**Decision Record**

Individual Environmental Report Supplemental #14.a  
WESTWEGO TO HARVEY LEVEE  
JEFFERSON PARISH, LOUISIANA

**FINAL INDIVIDUAL ENVIRONMENTAL REPORT  
SUPPLEMENTAL**

**WEST BANK AND VICINITY**

Figure 3. WBV-14.c.2 Cross-sectional view

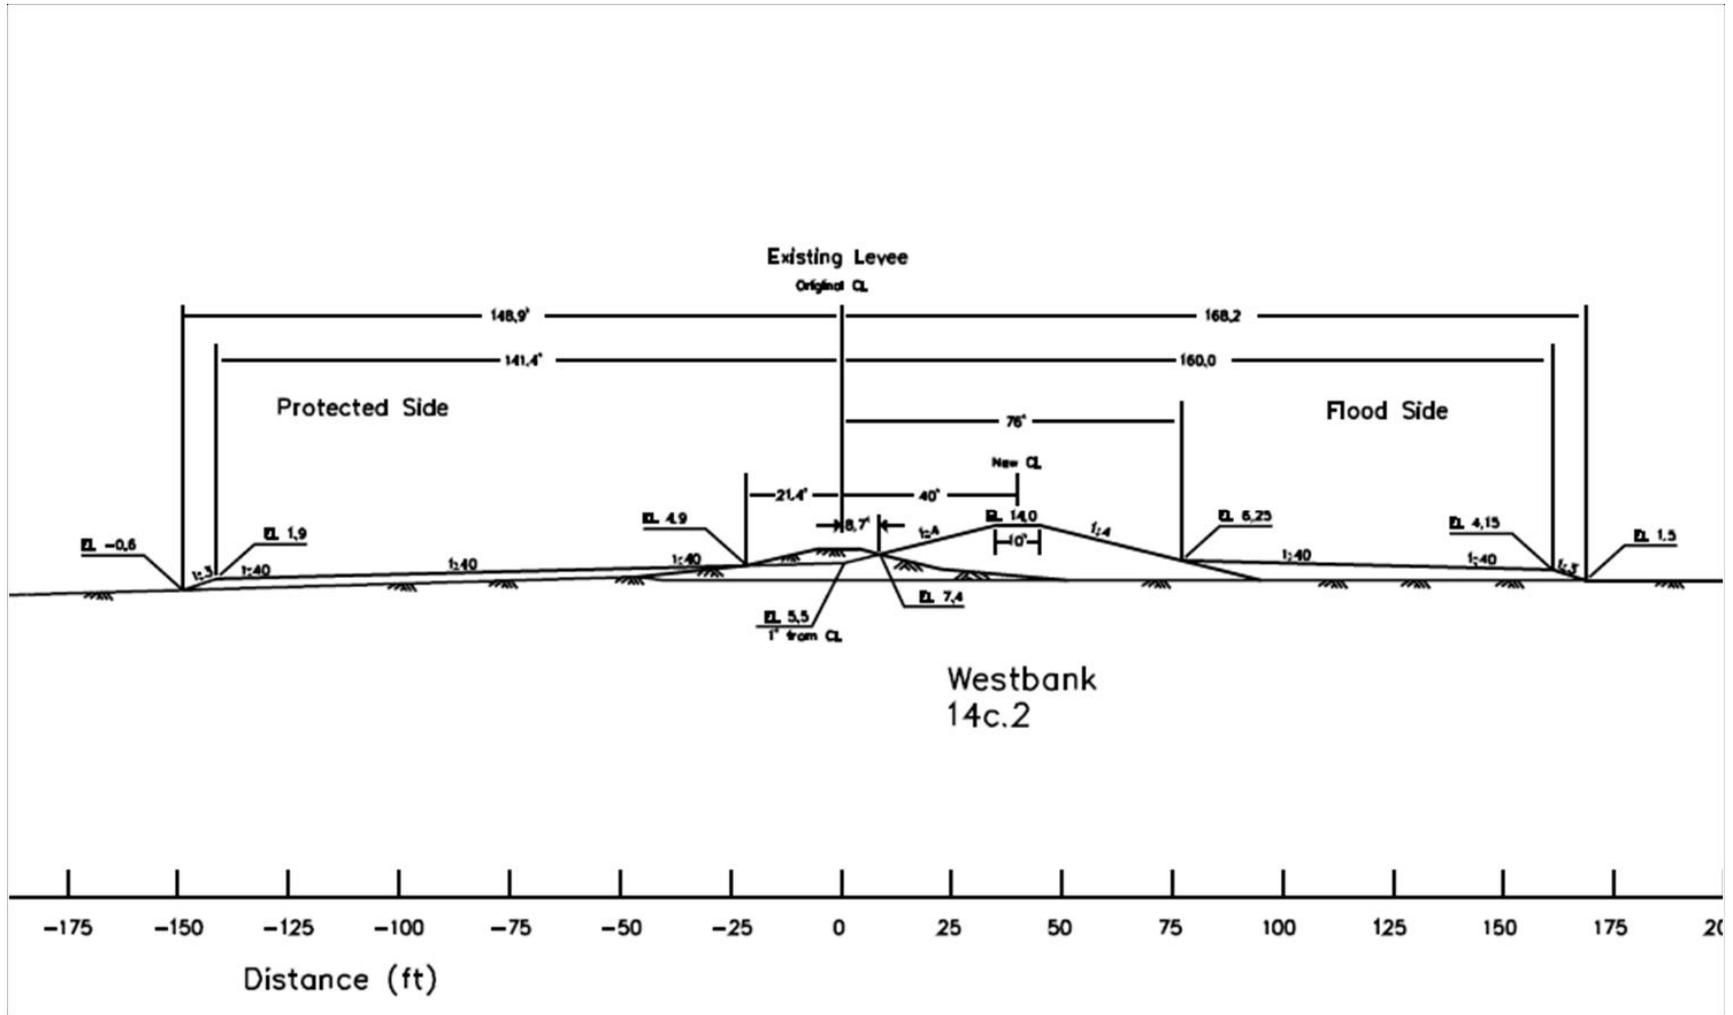
Please provide us with the new design criteria *i.e.*, "more rigorous design guidelines." The levee design has expanded from a 150 to a 325 ft footprint. (see Fig. 3). This is a 116% increase in the width.

Comment: "New Levee design guidelines: Please provide us with the new design criteria i.e., "more rigorous design guidelines." The levee design has expanded from a 150 to a 325 ft footprint. (see Fig 3). This is a 116% increase in width."
